#### **Addendum 86 – Regulation No. 87**

#### **Revision 3 - Amendment 1**

#### **Uniform provisions concerning the approval of daytime running lamps for power-driven vehicles**

Figure 1a

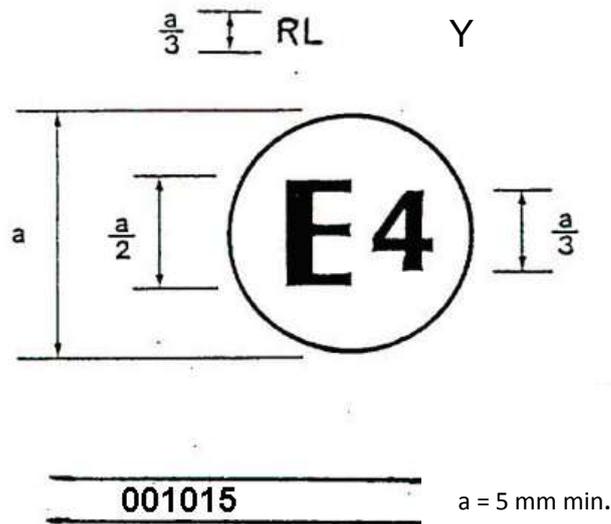
Insert a new example of the approval mark, to read (the amendment is marked in RED):

The lamp bearing the approval mark shown above has been approved in the Netherlands (E 4) under number 001015 as a part of an interdependent lamp system composing a daytime running lamp. The approval number indicates that the approval was granted according to the requirements of this Regulation in its original (un-amended) form."
